# UNITED STATES PATENT AND TRADEMARK OFFICE

10/721,857

Fred H. Burbank

## DETAILED ACTION

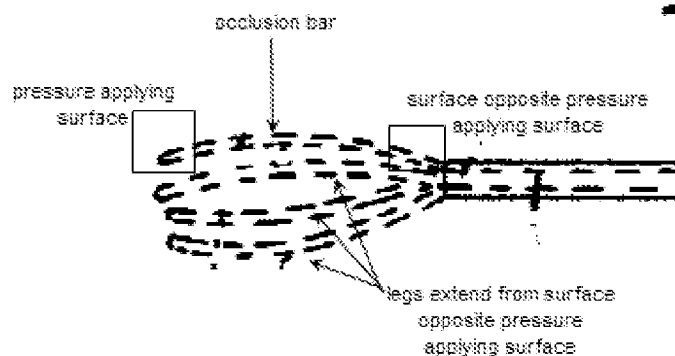
2. Claims 1-6, 47, 48 are rejected under 35 U.S.C. 102(b) as being anticipated by Hasson (US 5,562,680).

3. Hasson discloses an intravaginal device *capable of* occluding a female patient's uterine arteries with an unsymmetrical anatomy to treat a uterine disorder, comprising: a first occluding member having a first elongated shaft (14), a first operative proximal shaft section (88,90) configured to extend out of the patient during treatment, which has a first distal shaft section (18) with a first pressure applying occluding element (82) secured to the first distal shaft section (in that all the elements of the device are secured to each other), and a first mechanism/extending actuator (86, 92) to distally extend at

least part of the first pressure applying occluding element from a first position closer to the first operative proximal shaft section to a second position further away from the first operative proximal shaft section and for moving the first pressure applying surface distally away from the distal end of the first elongated shaft (Fig. 7; C6:L6-18); and a second occluding member (16) having a second elongated shaft, a second operative proximal shaft section configured to extend out of the patient during treatment and a second distal shaft section with a second pressure applying occluding element secured to the second distal shaft section; and a connection (46) between the first and second occluding members which is configured to adjust spacing between the first and second pressure applying occluding elements (C5: L13-20) to press the pressure applying occluding elements against the patient's vaginal wall to occlude underlying uterine arteries. Regarding claim 2 the second occluding member has a second mechanism to distally extend at least part of the second pressure applying occluding element from a first position closer to the second operative proximal shaft section to a second position further away from the second operative proximal shaft section (see Fig. 1 and above elements with respect to first occluding member). Regarding claim 3 the connection between the first and second occluding members is a pivotal connection (Fig. 5 and 6; C5: L17). Regarding claim 4, each of the proximal shaft sections of the occluding members includes a finger engaging grip (C6:L10-15). Regarding claim 5, at least part of the first pressure applying occluding element is configured for positional adjustment in-line with the first distal shaft section (Fig. 7). Regarding claim 6, at least part of the first pressure applying occluding element is configured for rotation within a plane at or

near the first distal shaft section (via pivot at connection (46) in Fig. 6). Regarding claims 47 and 48 the first pressure applying element includes an occlusion bar with a pressure applying surface and a pair of legs which extend from a surface opposite the pressure applying surface (see below).

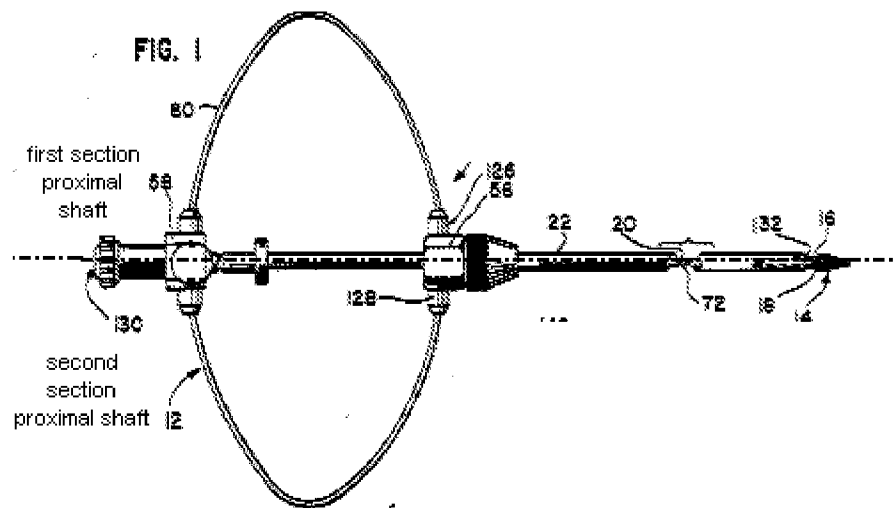
5. Regarding claim 32: Hasson discloses an intravaginal device *capable of* occluding a female patient's uterine arteries with an unsymmetrical anatomy to treat a uterine disorder, comprising: a first occluding member having a first elongated shaft (16), a first operative proximal shaft section configured to extend out of the patient during treatment (see below), a first distal shaft section (32) with a first pressure applying occluding element (28) secured to the first distal shaft section, and a first mechanism (one of spring 60) to distally extend at least part of the first pressure applying occluding element from a first position closer to the first operative proximal

shaft section to a second position further away from the first operative proximal shaft section (C4:L45-65); and a second occluding member having a second elongated shaft (18), a second operative proximal shaft section configured to extend out of the patient during treatment (see below) and a second distal shaft section (34) with a second pressure applying occluding element (30) secured to the second distal shaft section, wherein the second occluding member has a second mechanism (other of spring 60) to distally extend at least part of the second pressure applying occluding element from a first position closer to the second operative proximal shaft section to a second position further away from the second operative proximal shaft section; and a connection (at core 72) between the first and second occluding members which is configured to adjust spacing the first and second pressure applying occluding elements (core 72 is pushed distally, pushing occluding members distally, thereby adjusting spacing (C4:L45-65)) so that it is *capable of* pressing the pressure applying occluding elements against the patient's vaginal wall to occlude underlying uterine arteries, wherein the first pressure applying occluding element is pivotally connected (at pin 40) to the distal shaft section of the first occluding member and the first occluding member includes a third mechanism (112, C5:L46-63) for selectively rotating the first pressure applying occluding element relative to the distal shaft section of the first occluding member.
